Docket Number:	19-SPPE-02
Project Title:	Walsh Data Center
TN #:	232996
Document Title:	Walsh Data Center SVP Resource Plan CEC evaluation
Description:	Exhibit 504
Filer:	Robert Sarvey
Organization:	Robert Sarvey
Submitter Role:	Intervenor
Submission Date:	5/15/2020 3:17:30 PM
Docketed Date:	5/15/2020

STAFF REPORT

Review of Silicon Valley Power's 2018 Integrated Resource Plan

September 2019 | CEC-200-2019-017

Figure 1: Silicon Valley Power and California Energy Commission Energy Forecasts 2017-2030 (GWh)

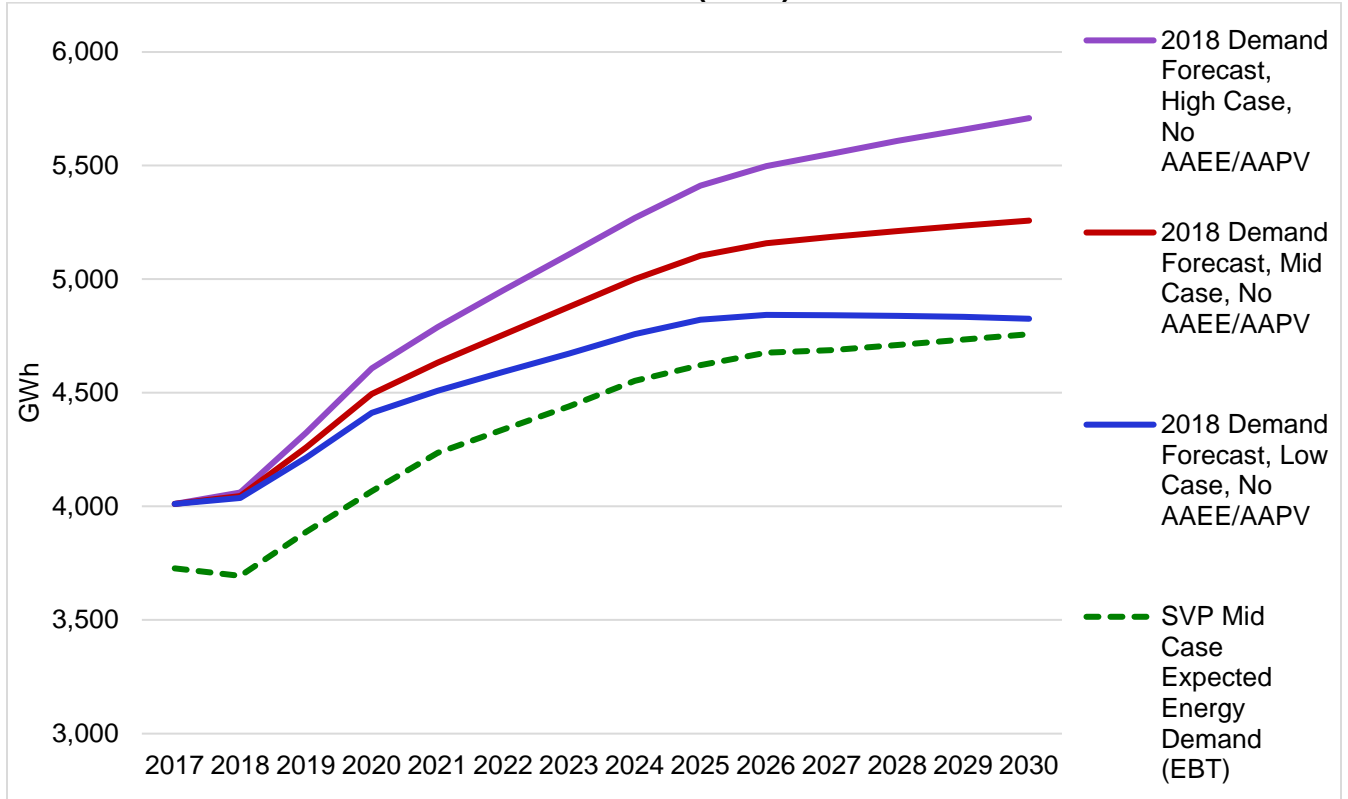
A comparison of SVP's forecasts of energy and peak demand to the CEC's *2018 Demand Forecast Update* is shown in **Figure 1** and **Figure 2**, respectively. SVP's expected growth scenario for energy starts below the CEC's low-demand case with no AAEE and AAPV, but increases over the forecast period to nearly the same level as the CEC's low-demand case with no AAEE and AAPV by 2030.⁷

Figure 2: Silicon Valley Power and California Energy Commission Peak Demand Forecasts 2018 — 2030 (MW)

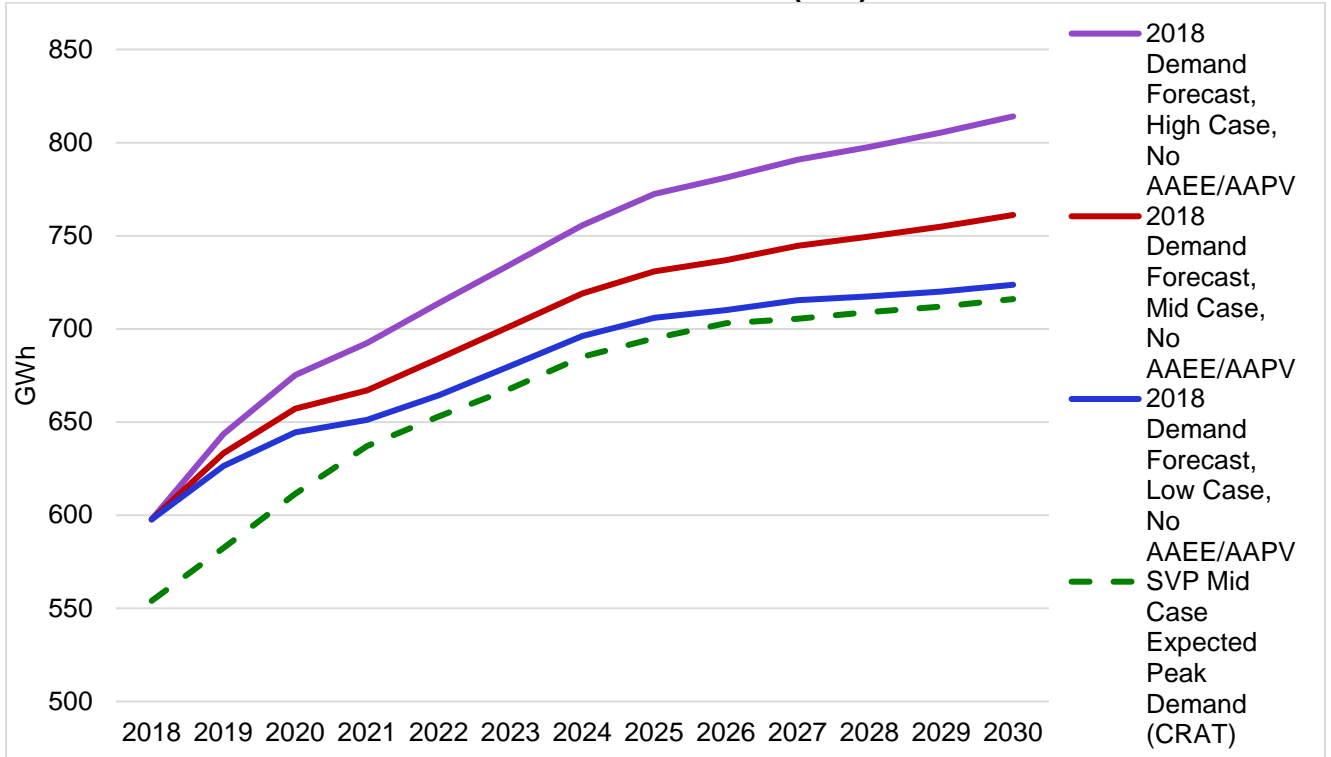
SVP's expected growth scenario for peak demand also starts below the CEC's low-demand case with no AAEE and AAPV, but increases to nearly the CEC's low-demand case with no AAEE and AAPV by 2021, then stays just below this case through 2030. This increase in peak demand may be attributed to information

Figure 4: SVP RPS Portfolios in 2019 and 2030

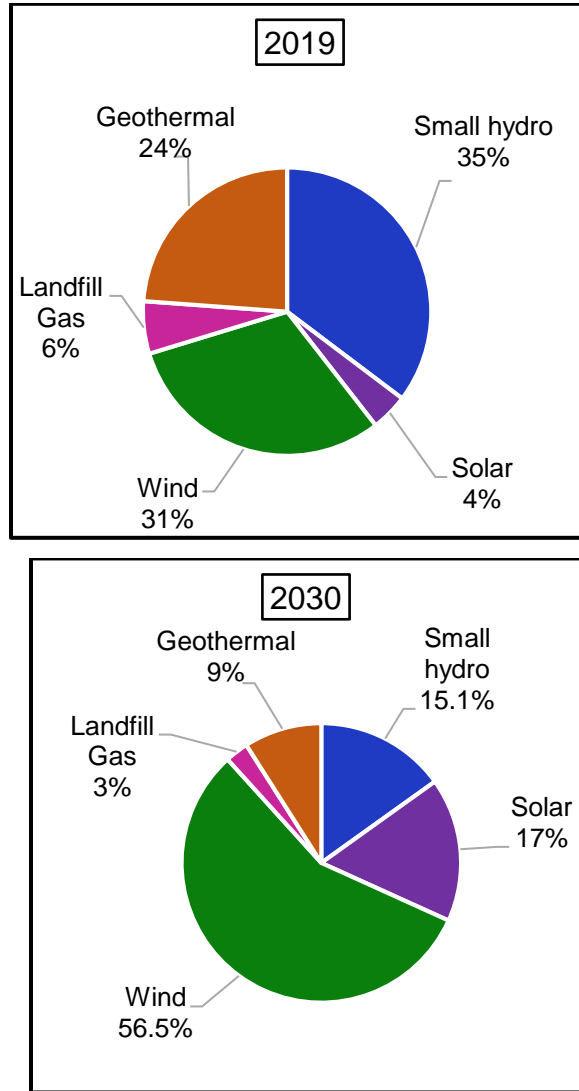
PCC 3 RECs used for compliance in periods 4 through 6. **Figure 4** shows the mix of renewable resources for 2019 and 2030.

Figure 6: SVP Portfolio Comparison for 2019 and 2030

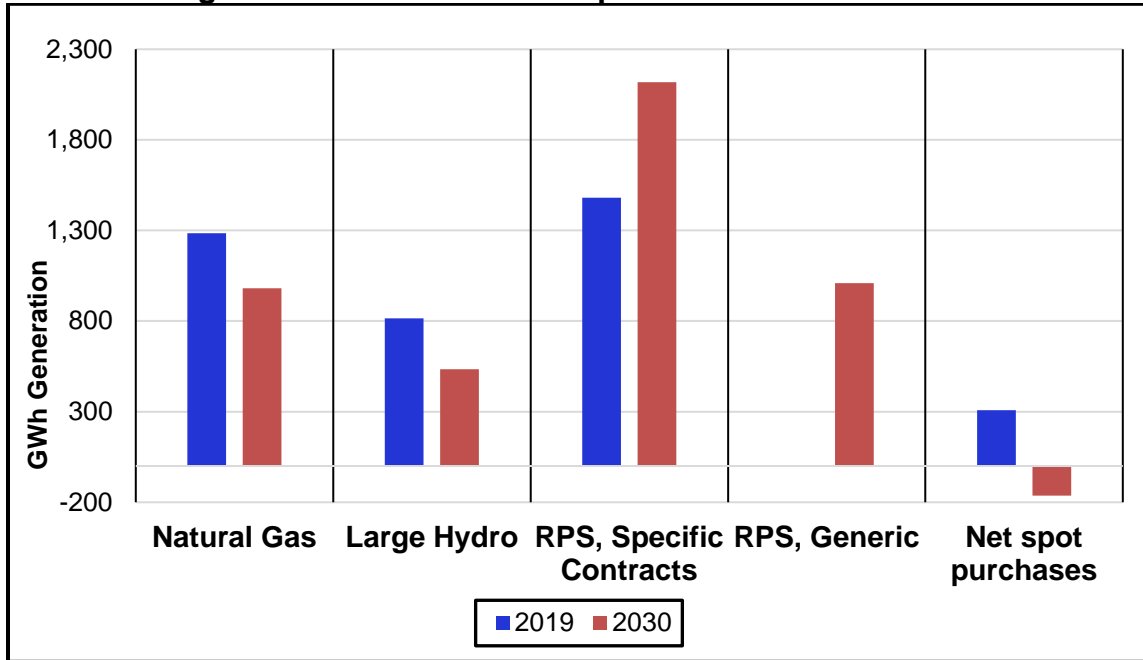
SVP faces the challenge of the expiration of its hydro contracts and decreasing dependable generation from its geothermal resources while planning to meet increasing demand with high load factors. The mix of RPS specific resources changes from 59 percent from small hydro and geothermal in 2019 to over 56 percent from wind in 2030. The Viento Loco wind project, which comes online in 2021 and 2022, will help meet increasing energy demand and compensate for the retirement of the Santa Clara Cogeneration facility. Starting in 2030, SVP plans to procure equal amounts of generic wind and solar resources to meet its demand, which will account for roughly 25 percent of its renewable resources.
